1997 Corvette: Service Bulletin: Erratic Fuel Gauge Readings

Number: 73-83-22

SUBJECT: ERRATIC FUEL GAUGE READINGS (REPAIR PINCHED WIRES)

MODELS: 1997 CHEVROLET CORVETTE

Figure 1

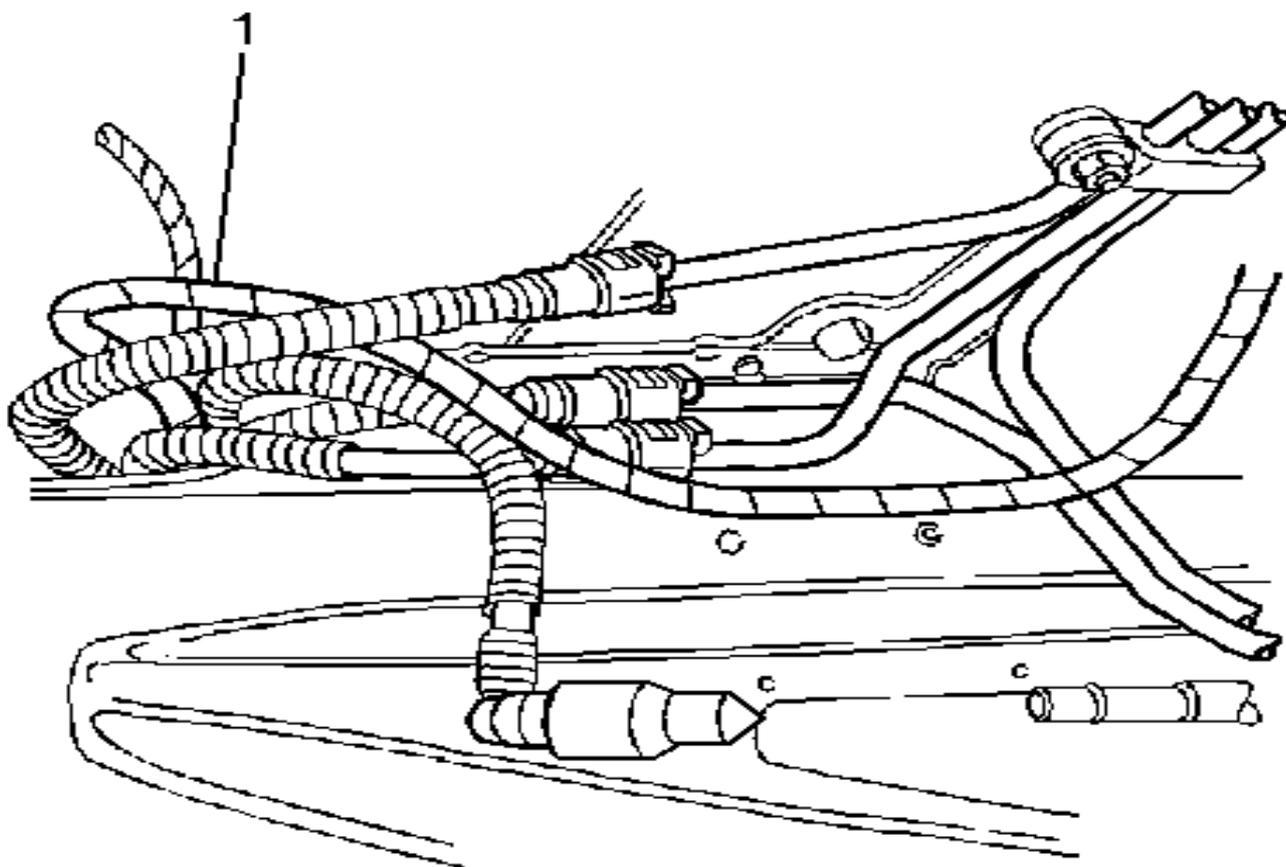
THE SENDER WIRES FROM EITHER TANK MAY BE TRAPPED UNDER THE FUEL OR EVAPORATOR LINES WHERE THE LINES ROUTE BETWEEN THE BODY AND THE FRAME RAIL IN THE REAR.

INSPECT THE AREA ABOVE FOR PINCHED WIRES. IF THE WIRES DO NOT MOVE FREELY, THEY MAY BE PINCHED. THE HARNESS IS #1 IN FIGURE 1.

REPAIR THE WIRES AS NECESSARY. MAKE SURE THAT THE WIRES ARE PROPERLY ROUTED, AND MOVE FREELY, TO INSURE THAT THEY WILL NOT BE PINCHED IN THE FUTURE. IT MAY BE NECESSARY TO REMOVE ONE OR BOTH FUEL TANKS FOR ACCESS TO THIS AREA. IF SO, FOLLOW THE PROCEDURES ON PAGE 6-970 IN THE SERVICE MANUAL.
